## **STAFF REPORT**

ITEM#: 4A – PUBLIC HEARING

**TO:** Planning Commission  
**FROM:** Ben Prchal, City Planner  
**AGENDA ITEM:** Variance Requests for 8126 Hill Trail N  
**REVIEWED BY:** Ken Roberts, Planning Director

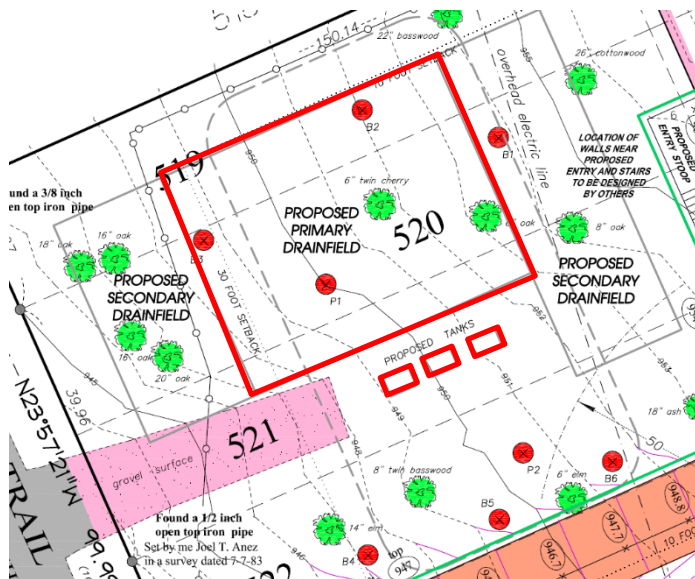
The proposed home would be outside the impact zone by 11 ft. but the setback from the OHWL of the houses on the adjacent lots averages to 66.5 ft. Unfortunately, the proposed home would be setback 64 ft. which is 2.5 ft. shy of being allowed without a variance. Because the proposed design cannot meet the average setback, a variance is required. With setback averaging being a possibility Staff likes to consider sightline impacts to the neighboring homes. The location of the home as compared to homes to the north and south is shown below and will likely not inhibit lake views for neighboring properties.

Shoreland Standard 154.800 12.

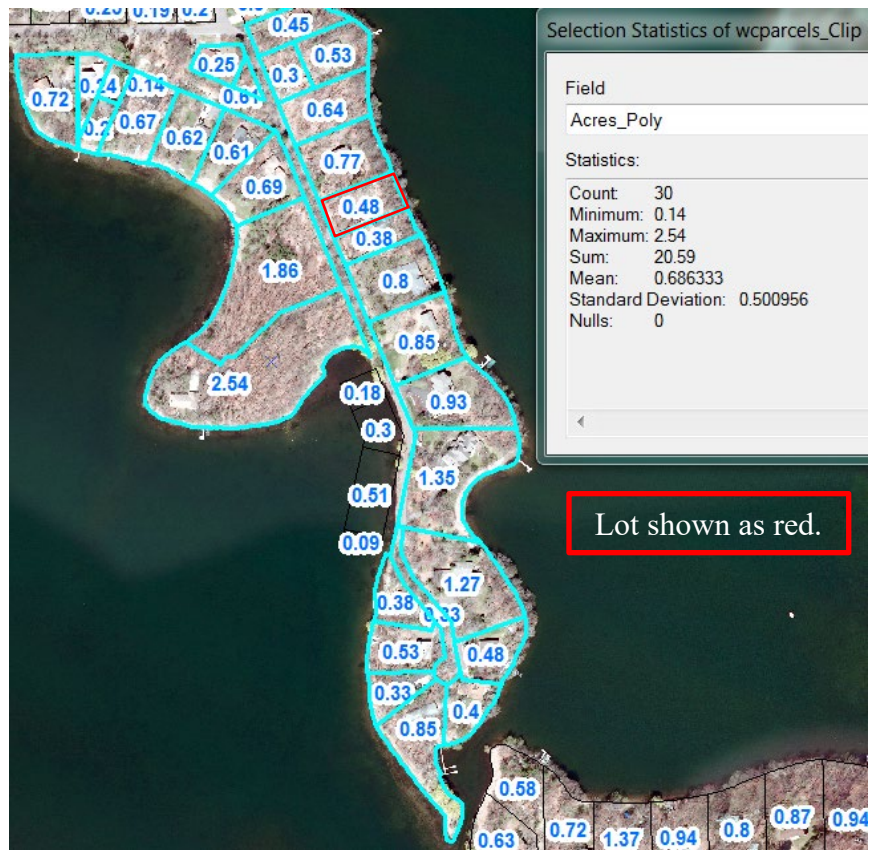
The minimum lot size for an unsewered single family detached dwelling within the shoreland district is 40,000 square feet. The lot size of the subject parcel is 20,706 square feet. The lot also does not meet the minimum shoreland district standards in Subdivision 12 of the shoreland ordinance which states that “All legally established nonconformities as of the date of this ordinance may continue, but will be managed according to Minnesota Statutes, Section 462.357 Subd. 1e and other regulations of this community for alterations and additions; repair after damage; discontinuance of use; and intensification of use.” Additionally, MN Statute 462.357 subd 1(e) subdivisions (d) through (j) specifically deal with shoreland lots of record that do not meet the requirements for lot size or lot width.

The map shows acreage of surrounding properties and more specifically shows the average (mean) of all the lots along the peninsula.
